NORTHEAST NUCLEAR ENERGY COMPANY
THE CONNECTICUT LIGHT AND POWER COMPANY
THE WESTERN MASSACHUSETTS ELECTRIC COMPANY
DOCKET NO. 50-336
MILLSTONE NUCLEAR POWER STATION, UNIT NO. 2
AMENDMENT TO FACILITY OPERATING LICENSE

Amendment No. 117
License No. DPR-65

ATTACHMENT TO LICENSE AMENDMENT NO.117

SAFETY EVALUATION BY THE OFFICE OF NUCLEAR REACTOR REGULATION

FIGURE 3.9-1 MINIMUM REQUIRED FUEL ASSEMBLY EXPOSURE AS A FUNCTION OF INITIAL ENRICHMENT TO PERMIT STORAGE IN REGION 2

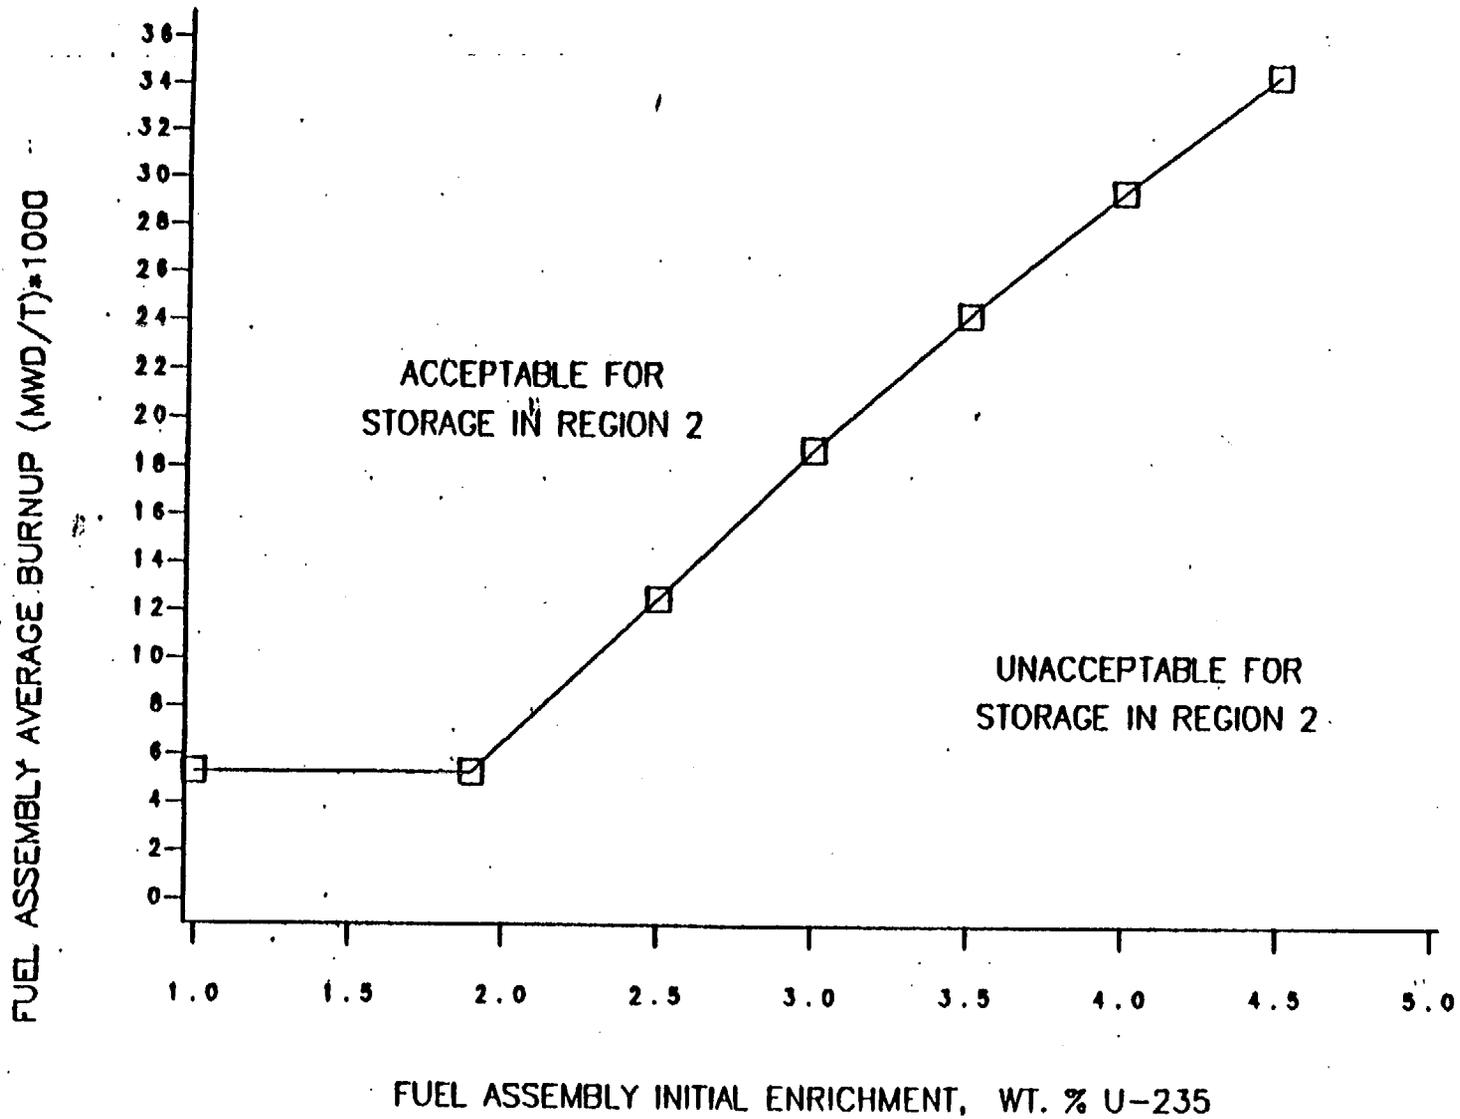
The limitations described by Figure 3.9-1 ensure that the reactivity of fuel assemblies and consolidated fuel storage boxes, introduced into the Region II spent fuel racks, are conservatively within the assumptions of the safety analysis.

SPENT FUEL POOL ARRANGEMENT UNIT #2
FIGURE 3.9-2

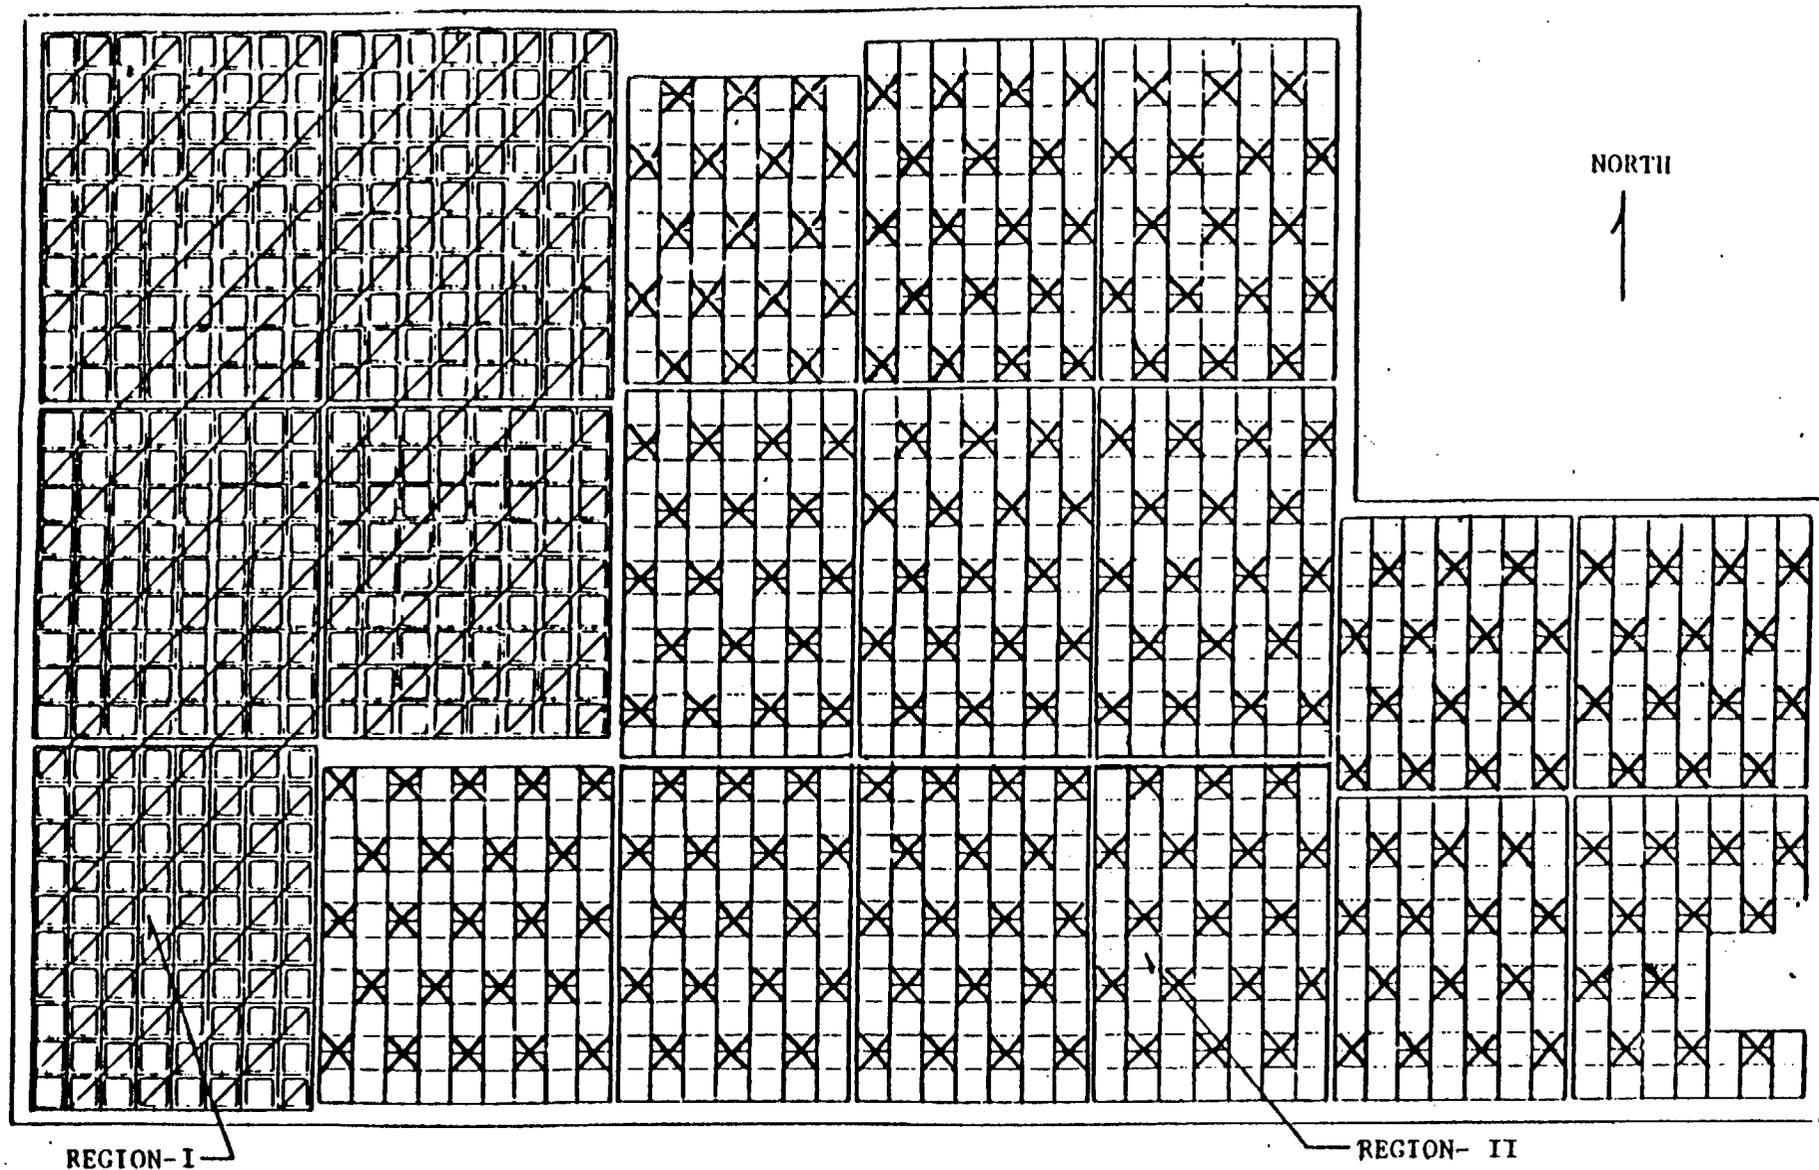
4.9.18.1 Ensure that all fuel assemblies to be placed in Region II (as shown in Figure 3.9-2) of the spent fuel pool are within the enrichment and burn-up limits of Figure 3.9.1 by checking the assembly's design and burn-up documentation.

- (1) A cell blocking device is installed in those cell locations shown in Figure 3.9-2; or
- (2) If a cell blocking device has been removed, all cells of the STORAGE PATTERN must have consolidated fuel in them, including the formerly blocked location; or
- (3) Meet both (a) and (b):
 - (a) If a cell blocking device has been removed, all cells of the STORAGE PATTERN must have consolidated fuel in them except the formerly blocked location.
 - (b) The formerly blocked location is vacant and a consolidated fuel box or cell blocking device is immediately being placed into the formerly blocked cell.

FIGURE 3.9-3 MINIMUM REQUIRED FUEL ASSEMBLY EXPOSURE AS A FUNCTION OF INITIAL ENRICHMENT TO PERMIT STORAGE IN REGION 2 AS CONSOLIDATED FUEL

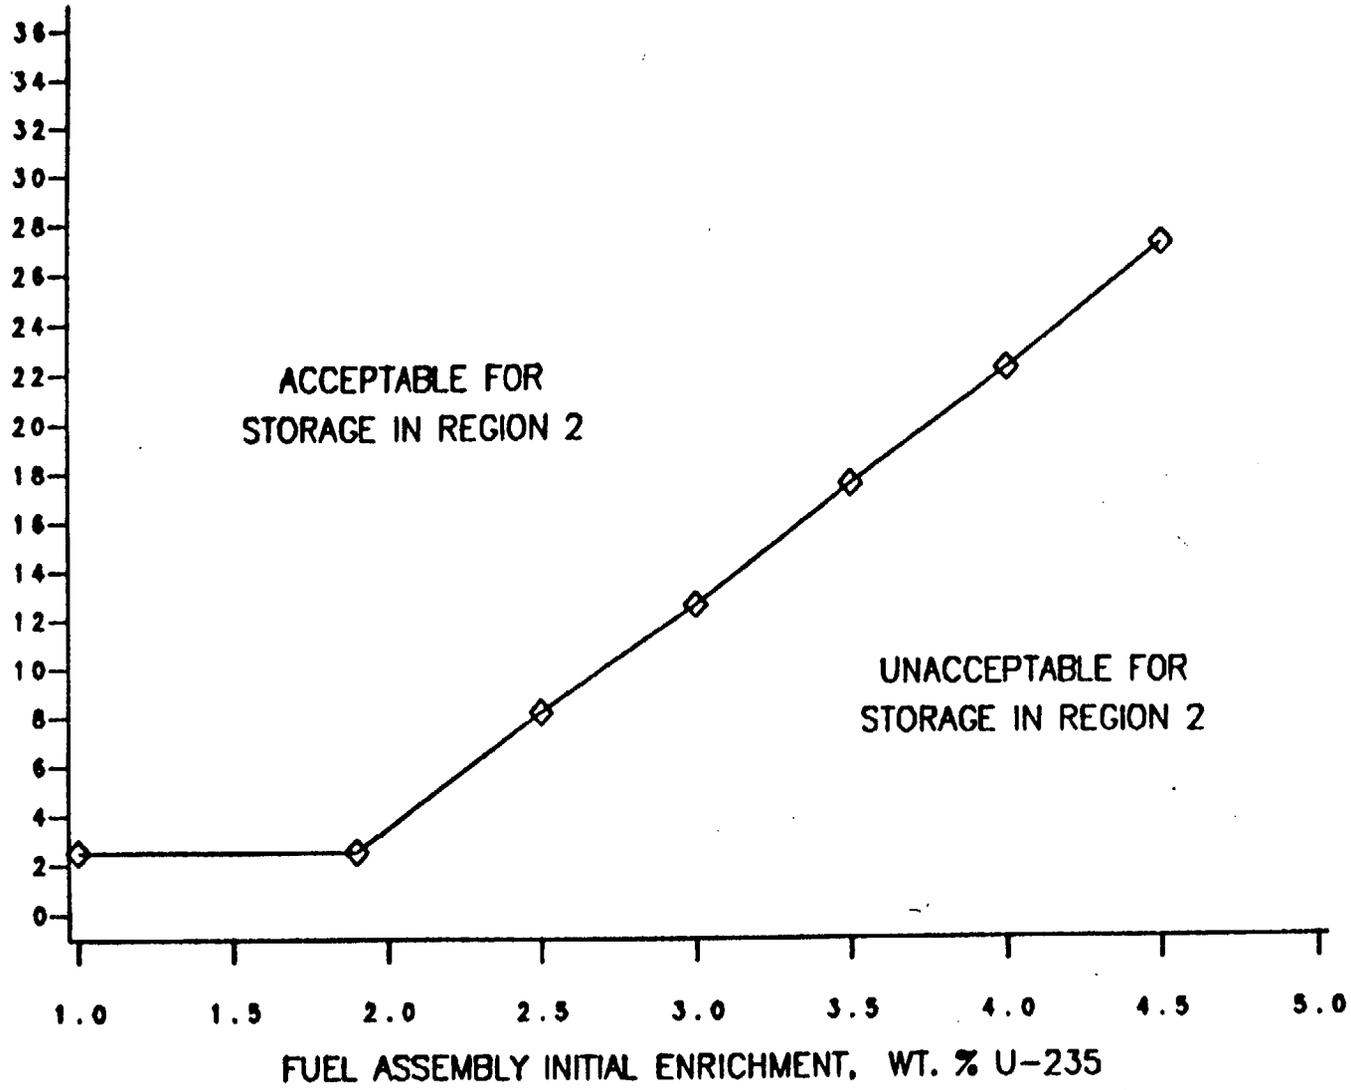
4.9.18.2 Ensure that the contents of each consolidated fuel storage box to be placed in Region II (as shown in Figure 3.9-2) of the spent fuel pool are within the enrichment and burn-up limits of Figure 3.9-3 by checking the design and burn-up documentation for storage box contents.

c) Region II of the spent fuel storage pool is designed and shall be maintained with a 9.0 inch center to center distance between storage locations to ensure a $K_{eff} < .95$ with the storage pool filled with unborated water. Fuel assemblies stored in this region must comply with Figure 3.9-1 to ensure that at least 85% of the design burn-up has been sustained. The contents of consolidated fuel storage boxes to be stored in this region must comply with Figure 3.9-3.

A change to TS 4.9.18 is proposed to incorporate enrichment and burn-up limits in the TS for storage of consolidated spent fuel. Section 2.1, herein, addresses the enrichment/burn-up curves for storage of consolidated spent fuel.
